City of
Melville

DEVELOPMENT ADVISORY UNIT MEETING

UP25/82 Two Grouped Dwellings at Lot 30 (No. 50) Blackwall Reach Parade, Bicton

Voting Requirements:	Simple Majority
Officer Disclosure of Interest:	Nil
Application Number:	DA-2025-8
Applicant:	Stian Stutlien
Owner:	David James Gaunt
Proposal:	Two Grouped Dwellings
Attachments:	1. Development Plans

Figure 3. Unit 2 Northern Elevation with Blue Area Showing Bed 1 Roof Over 9m.

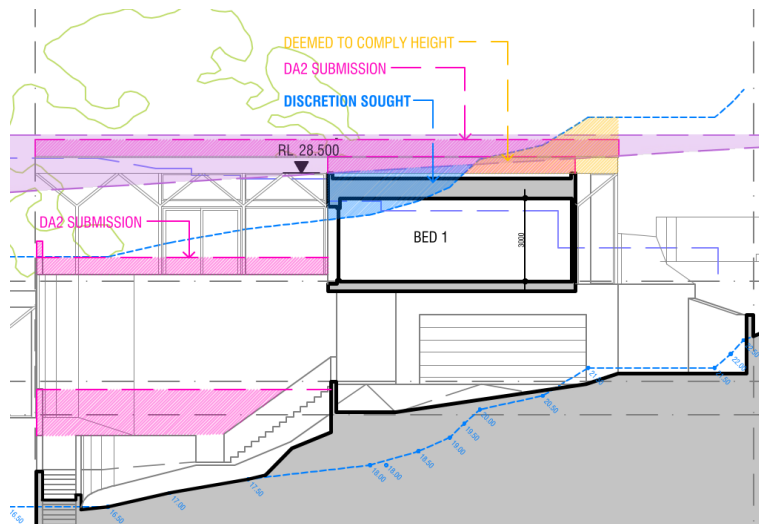
Concerns were raised by the submitters in relation to the building height of proposed Unit 2. As noted above, the proposed development does not meet the deemed to comply provisions within LPP1.9 in and requires a R-Codes design principles assessment. The proposed development is considered to meet the relevant design principles as discussed below:

Design Principles	Assessment:
<p><i>P6: Building height that creates no adverse impact on the amenity of adjoining properties or the streetscape, including road reserves and public open space reserves; and where appropriate maintains:</i></p> <ul style="list-style-type: none"> • <i>adequate access to sunlight into buildings and appurtenant open spaces;</i> • <i>adequate daylight to major openings into habitable rooms; and</i> • <i>access to views of significance.</i> 	<p>P6:</p> <ul style="list-style-type: none"> • Overall, the subject site has a fall of approximately 11m from both east to west and north to south which creates a significant design challenge for the proposed development especially regarding building height. While the entirety of Unit 1 and the majority of Unit 2 meet the deemed-to-comply height criteria, a steep drop in ground level of approximately 6.5m below proposed Unit 2’s bed 1 (figure 2) results in the roof exceeding 9m in height above NGL in this location. The applicant has provided figures 3 and 4 below which show the portion of the Unit 2 bed 1 that exceeds 9m in height in blue. • The proposal complies with Clause 5.4.2 ‘Solar access to adjoining sites’ which ensures there will be adequate sunlight available for adjoining properties despite the height of proposed Unit 2. • When considering the subject sites topography, it is considered the impact on No.4 Lindsay Place’s views of significance will be minimal for the following reasons: <ul style="list-style-type: none"> ○ Figure 3 below shows in yellow the rear portion of Unit 2 could be constructed higher as of right while still meeting the 9m maximum deemed-to-comply height criteria. This portion shown in yellow would cause more disruption to the views of No.4 Lindsay Place than the portion of the Unit 2 bed 1 roof for which discretion is sought. ○ Views from No.4 Lindsay Places first floor are depicted in figures 5 and 6 below where impacts on views of significance will be minimal. Specifically, there is only one bedroom on the first floor of No.4 Lindsay Place directly facing the portion of the proposed dwelling over 9m in height. In addition, the proposed bed 1 roof (reduced level (RL) 28.50m) will be approximately 0.8m higher than the finished floor level (FFL) of No.4 Lindsay Places first floor (RL 27.70m) which will still allow for views of the river from No.4 Lindsay Places first floor. ○ The second floor of No.4 Lindsay Place has an FFL above the roof level of the proposed dwelling and therefore will be unaffected as depicted in figures 7 and 8 below. • No other surrounding properties will have a loss of significant views because of proposed Unit 2’s bed 1 roof height.

Figure 9. Unit 1 Western Bed 1 to Bed 2 Wall Setback from No.50A Blackwall Reach Parade Boundary Marked in Yellow.

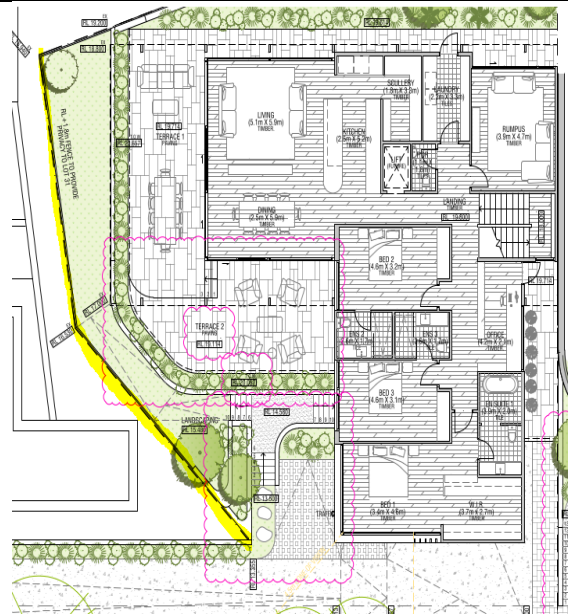
Concerns were raised by the submitters in relation to the side lot boundary setback non-compliances proposed. As noted above in the requirements section, various side lot boundary setbacks for proposed Unit 1 and 2 do not meet the deemed to comply provisions of the R-Codes and requires a design principles assessment. The proposed development is considered to meet the relevant design principles as discussed below:

Design Principles	Assessment:
<p>P3.1: Buildings set back from lot boundaries or adjacent buildings on the same lot so as to:</p> <ul style="list-style-type: none"> • reduce impacts of building bulk on adjoining properties; • provide adequate sunlight and ventilation to the building and open spaces on the site and adjoining properties; and • minimise the extent of overlooking and resultant loss of privacy on adjoining properties. 	<p>P3.1:</p> <ul style="list-style-type: none"> • When considering the lot boundary setbacks, it is important to note that the subject site has a steep topography which creates a significant challenge for the proposed dwellings design. • When considering the sites topography, it is considered the bulk impacts of the proposed lot boundary setbacks will be minimal on adjoining properties for the following reasons: <ul style="list-style-type: none"> <u>No.50A Blackwall Reach Parade</u> <ul style="list-style-type: none"> ○ As per figure 9, a section of approximately 2.3m in length and 2.6m² in area of the Unit 1 bed 1 to bed 2 wall will be within 4.1m-6.3m of the lot boundary. This portion of wall is not considered to be excessive in size therefore minimising bulk impacts. ○ The Unit 1 bed 1 to bed 2 wall will be setback approximately 9.3m from No. 50A Blackwall Reach Parade’s master bedroom courtyard. As such, this

Figure 10. Unit 1 Western Terrace Setback from No.50A Blackwall Reach Parade.

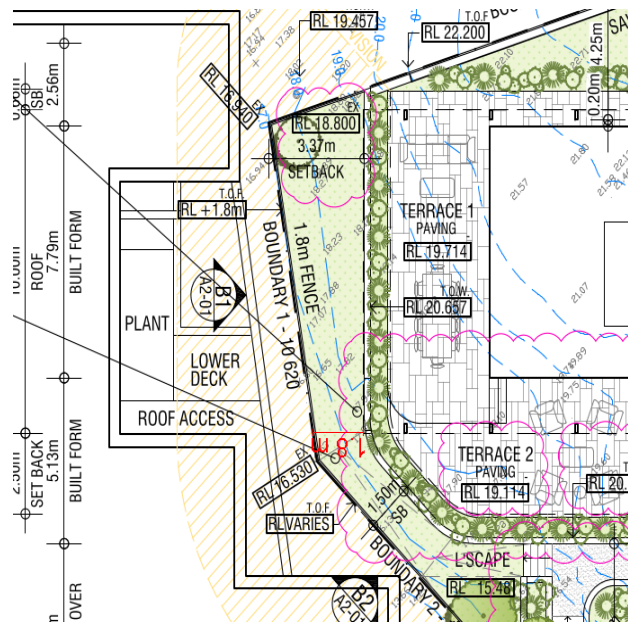
<p>wall, is sufficiently setback from the dwelling at No. 50A Blackwall Reach Parade to avoid unacceptable bulk impacts.</p> <ul style="list-style-type: none"> ○ Proposed Unit 1's terrace is an open structure. ○ There are no habitable rooms with major openings at No. 50A Blackwall Reach Parade facing the subject site. The proposed Unit 1 terrace roof will be adjacent to a drying court, lightwell and mechanical plant at No. 50A Blackwall Reach Parade. Given there are no habitable rooms at 50A Blackwall Reach Parade with major openings facing the proposed terrace and the terrace will not directly abut any sensitive spaces, the bulk impacts are deemed acceptable. <p><u>No.4 Lindsay Place</u></p> <ul style="list-style-type: none"> ○ A section of approximately 2.5m in length and 0.9m² in area of the Unit 2 rumpus to stairs wall will be within 1.5m of the lot boundary with No.4 Lindsay Place as per figure 12. The height of this portion of the wall is between 3.7m to 4.5m above NGL at the boundary noting that this portion of the building complies with LPP 1.9 'Height of Buildings'. This portion of the wall is not considered to be excessive in size therefore minimising bulk impacts. ○ The majority of No.4 Lindsay Place's outdoor living area will be unaffected by the proposed Unit 2 rumpus to stairs. No.4 Lindsay Places ground floor family room is adjacent to this portion of wall and is setback approximately 5.9m which is considered sufficient to ensure minimal bulk impacts. The first floor of No.4 Lindsay Place has an FFL higher than the roof level of proposed Unit 2 and will not be impacted. <p><u>No.2 Lindsay Place</u></p> <ul style="list-style-type: none"> ○ Proposed Unit 2's terrace and living will not abut any sensitive spaces at No.2 Lindsay Place. <ul style="list-style-type: none"> ● In terms of solar access, the proposal meets the deemed-to-comply criteria under Clause 5.4.2 'Solar Access for Adjoining Sites'. ● The proposed overlooking of adjacent properties is considered to result in minimal loss of privacy as justified below under the design principles assessment for Clause 5.4.1 'Visual Privacy'.

Figure 15. Western Boundary Retaining Walls Marked in Brown and Blue.

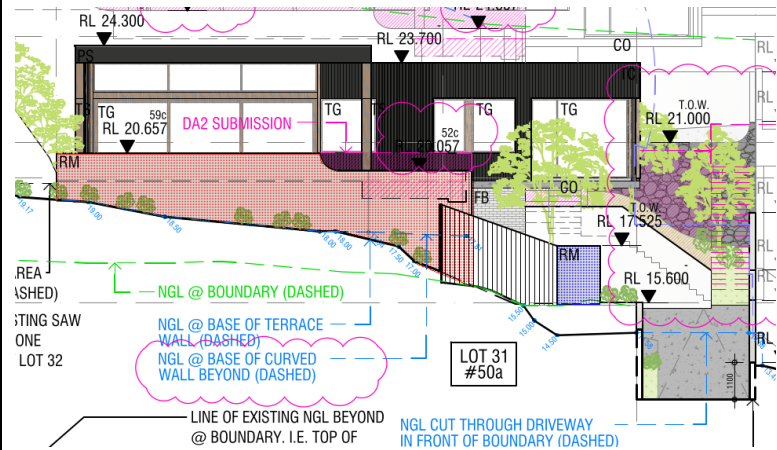
Concerns were raised by some objectors regarding the extent of retaining walls proposed abutting adjoining sites. As noted above, the proposed development does not meet the deemed to comply provisions in Volume 1 Part B of the R-Codes and requires a design principles assessment. The proposed development is considered to meet the relevant design principles as discussed below:

Design Principles	Assessment:
<p>P7.1: Development that considers and responds to the natural features of the site and requires minimal excavation/fill.</p> <p>P7.2: Where excavation/fill is necessary, all finished levels respecting the natural ground level at the lot boundary of the site and as viewed from the street.</p> <p>P7.3: Retaining walls that result in land which can be effectively used for the benefit of residents and do not detrimentally affect adjoining properties and are designed, engineered and landscaped having due regard to clause 5.4.1.</p>	<p>P7.1:</p> <ul style="list-style-type: none"> The site has a challenging topography with a fall of approximately 11m from both east to west and north to south. The design of the dwellings and the proposed retaining walls are considered to appropriately respond to the site’s natural topography. <p>P7.2:</p> <ul style="list-style-type: none"> Due to the majority of the siteworks along the driveway being cut, the impacts on the streetscape will be minimal. <p>P7.3:</p> <ul style="list-style-type: none"> The proposed retaining walls will result in land which can be effectively used for the benefit of residents and will not detrimentally affect adjoining properties for the following reasons: <p><u>Western Boundary:</u></p> <ul style="list-style-type: none"> Figure 15 below shows the two separate retaining walls along the western boundary in red and blue that do not meet the deemed-to-comply site work criteria. The red terrace retaining wall ranges in height from 3.7m to 4.4m as per figures 16 and 17 and is within 3m of the boundary with No. 50A Blackwall Reach Parade as per figure 18. The blue retaining wall is 2m high and is located on the boundary as per figures 16-18.

- Regarding the spaces at No.50A Blackwall Reach Parade that the proposed retaining walls will be adjacent to, figure 18 shows these include a drying court, lightwell, mechanical plant and the master suite courtyard. No habitable rooms with major openings at 50A Blackwall Reach Parade face the proposed retaining walls. In addition, No.50A Blackwall Reach Parade’s primary living space and outdoor living area are located on the western and north-western portions of their dwelling away from the proposed retaining walls. As such, it is considered the proposed retaining walls will not detrimentally affect No.50A Blackwall Reach Parade as they will not directly abut any sensitive spaces.

Figure 19. Height of Southern Boundary Retaining Wall with Wall in Pink Being Originally Proposed and Wall in Yellow Being Currently Proposed.

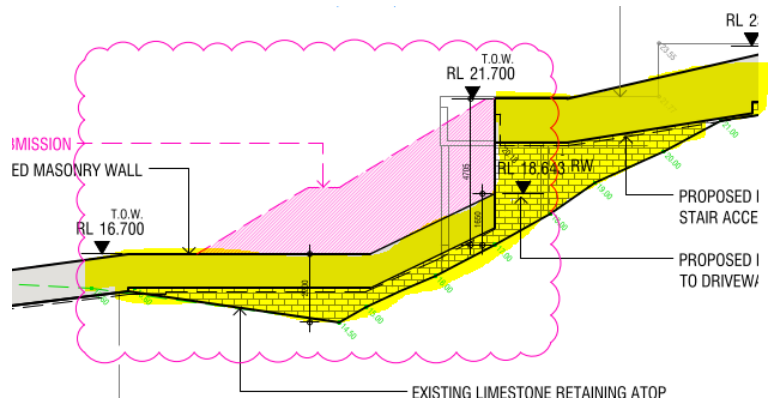
- The 4.7m high combined retaining and masonry wall along the southern boundary shown in figure 19 below is necessary to provide both vehicular and pedestrian access. The proposal involves mostly cut along the western portion of the access which is then balanced with retaining above NGL further up the site. A small portion of the masonry wall exceeds 0.5m in height where it abuts No.52 Blackwall Reach Parade with the majority of the combined retaining and masonry wall abutting 11 Barker Pl. The small portion of the masonry wall over 0.5m above NGL abutting No.52 Blackwall Reach Parade will have minimal impacts as it does not directly abut any sensitive spaces. Figure 20 below shows the highest portion of the southern retaining and masonry wall in relation to 11 Barker Place where it can be seen that the FFL of their dwelling is a similar height to the top of the retaining wall. Figure 21 also shows No.11 Barker Place only contains one window facing the subject site. It is therefore considered the

impacts on No.52 Blackwall Reach Pde and No.11 Barker Place from the proposed site works are acceptable.

Figure 23. Unit 1 Bed 1 overlooking into Nos. 50A and 52 Blackwall Reach Parade to the west and south.

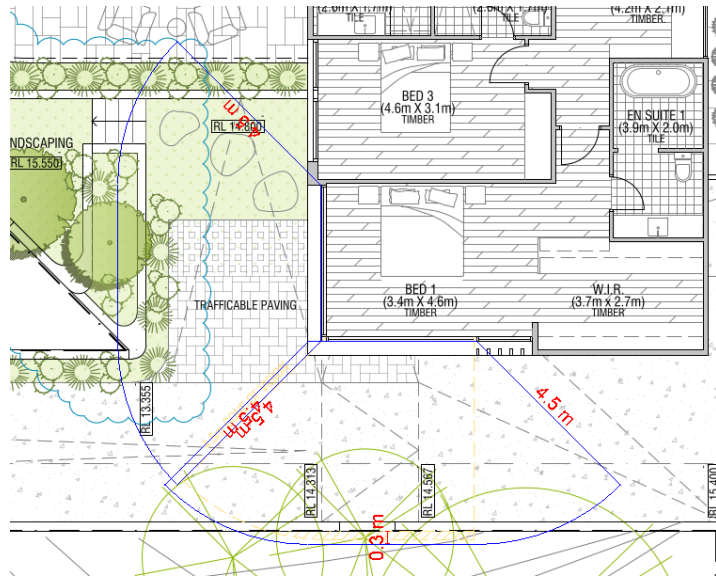
Concerns were raised by some objectors regarding the extent of overlooking into adjoining sites. As noted above, aspects of the proposed development do not meet the deemed to comply provisions in Volume 1 Part B of the R-Codes and requires a design principles assessment. The proposed development is considered to meet the relevant design principles as discussed below:

Design Principles	Assessment:
<p>P1.1: Minimal direct overlooking of active habitable spaces and outdoor living areas of adjacent dwellings achieved through:</p> <ul style="list-style-type: none"> • building layout and location; • design of major openings; • landscape screening of outdoor active habitable spaces; and/or • location of screening devices. <p>P1.2: Maximum visual privacy to side and rear boundaries through measures such as:</p> <ul style="list-style-type: none"> • offsetting the location of ground and first floor windows so that viewing is oblique rather than direct; • building to the boundary where appropriate; • setting back the first floor from the side boundary; • providing higher or opaque and fixed windows; and/or 	<p>P1.1 and P1.2:</p> <ul style="list-style-type: none"> • Figure 23 below shows the overlooking from Unit 1 Bed 1’s major opening of Nos. 50A and 52 Blackwall Reach Parade will be minimal. Specifically, the cone of vision overlooking of No.52 Blackwall Reach Parade will extend approximately 0.3m over the boundary and not impact any active habitable spaces. Therefore, the Unit 1 bed 1 overlooking is considered to have minimal privacy impacts. • Figure 24 shows the cone of vision overlooking from the Unit 1 Terrace towards No.50A Blackwall Reach Parade. This overlooking does not capture any major openings at No.50A Blackwall Reach Parade and the outdoor areas it captures include a drying court, lightwell, mechanical plant and master courtyard with a louvered roof. The overlooking therefore will not have any privacy effects on No. 50A Blackwall Reach Parade’s primary living space or primary outdoor living area. Figures 24 and 25 below highlight the sites steep topography with the primary outlook towards the river over top of No.50A Blackwall Reach Parade. A 1.8m fence is also proposed along this boundary which as can be seen in figure 26 below which will prevent a direct line of sight down towards No.50A Blackwall Reach Parade from a person standing on the terrace.
